Final Environmental Statement

related to the operation of
Enrico Fermi Atomic Power Plant,
Unit No. 2

Docket No. 50-341

**U.S. Nuclear Regulatory
Commission**

Figure 6.2 Probability distribution of individual dose impacts

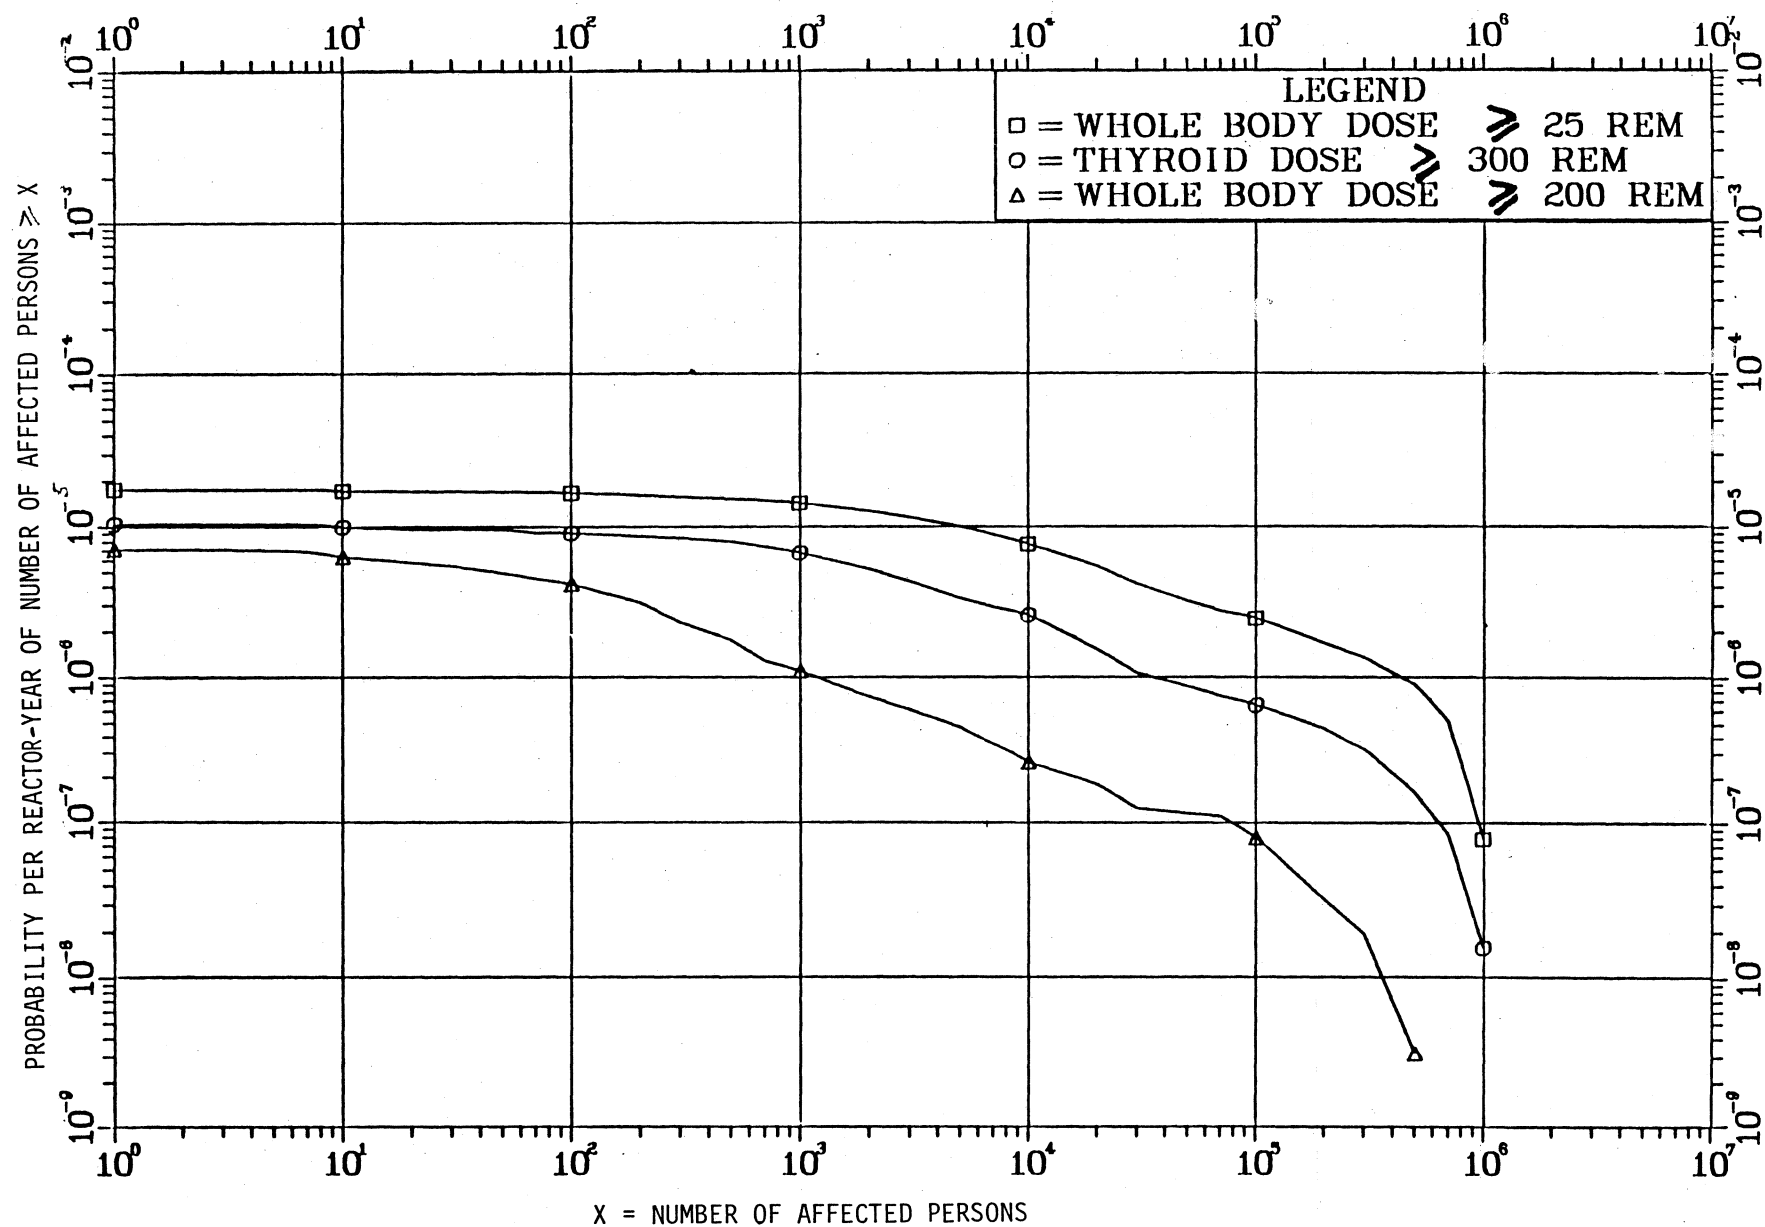
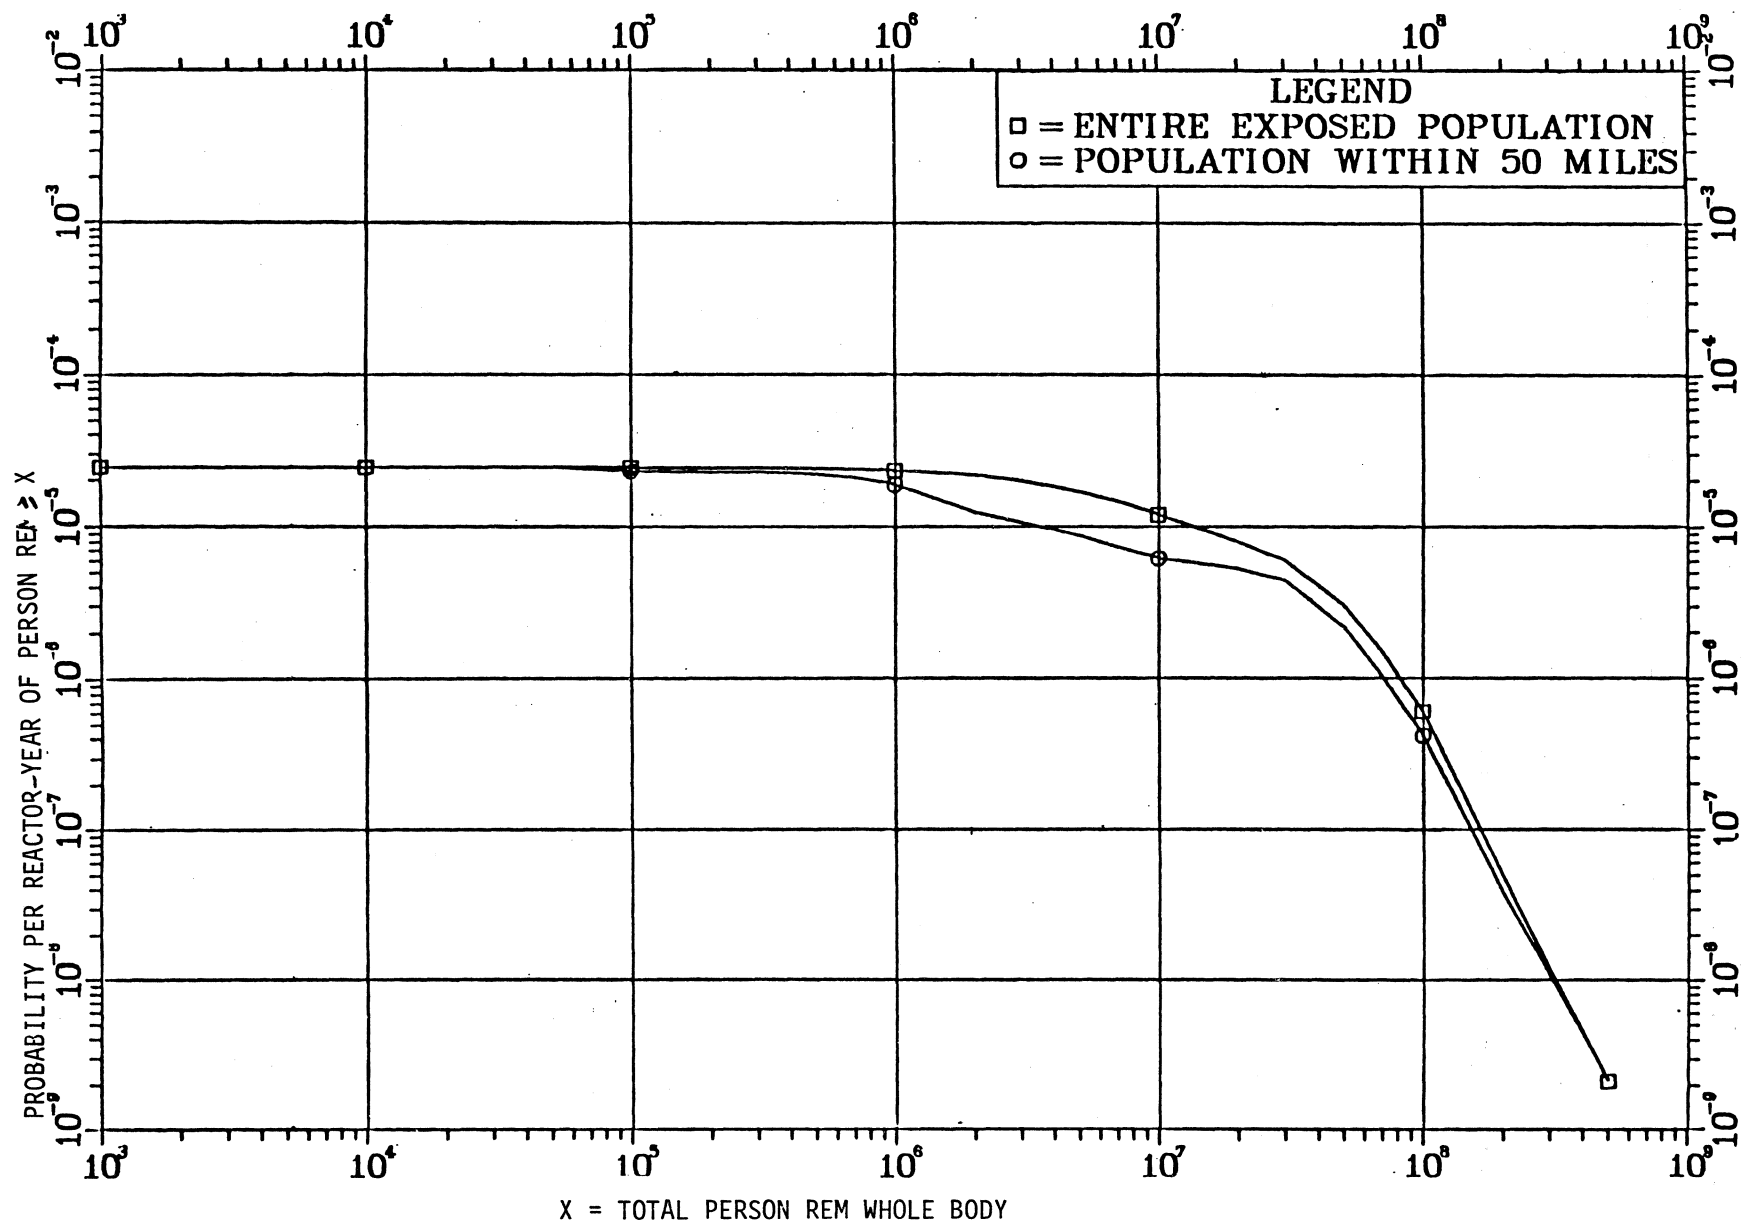
- a. The captions on Figures 6.2 and 6.3 have been inadvertently switched.
- b. Figure 6.7, Individual Risk of Dose as a Function of Distance, is hard to interpret since there are only two cryptic sentences devoted to it, at the bottom of page 6-29. It does not appear to add any useful information to that presented in other tables and figures in the analysis and there are no conclusions that depend on it. It would be better if it were omitted.

The applicant's comments regarding Figure 6.7 and Table 6.3 have been noted. The applicant's comments regarding the captions for Figures 6.2 and 6.3 were noted and the appropriate changes made.

Figure 6.8 Isopleths of risk of acute fatality per reactor-year to an individual

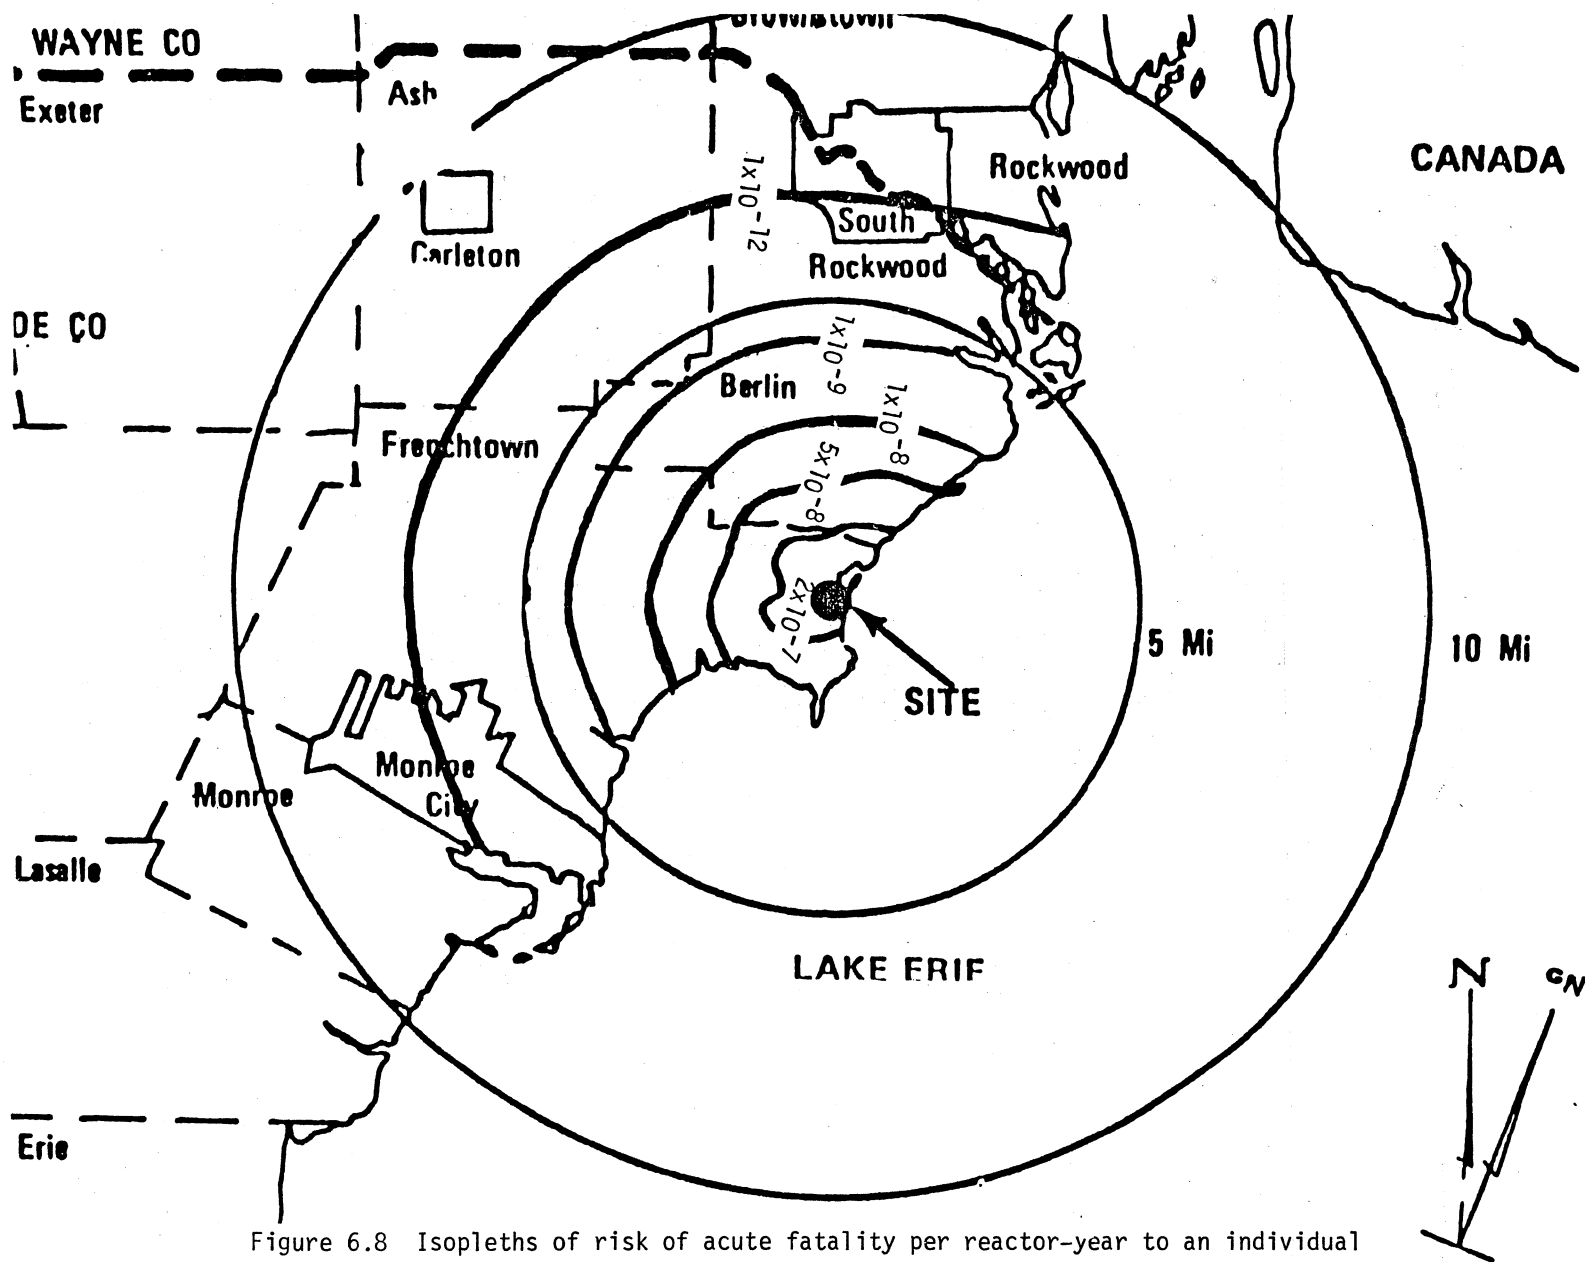
- c. The Applicant has reservations about the use of numbers as low as 10^{-12} per year for the isopleths of the risk of acute fatality per year to an individual as shown on Figure 6.8; 10^{-12} per year means once in a thousand billion years, that is, once in a period that exceeds a hundred times the age of the earth. Numbers of this nature can have no meaning.

The applicant commented on the use of the Calculation of Reactor Accident Consequences (CRAC) computer code and on the use of individual risk of 10^{-12} per reactor year in the isopleths of the risk of acute fatality per reactor year (Figure 6.8).
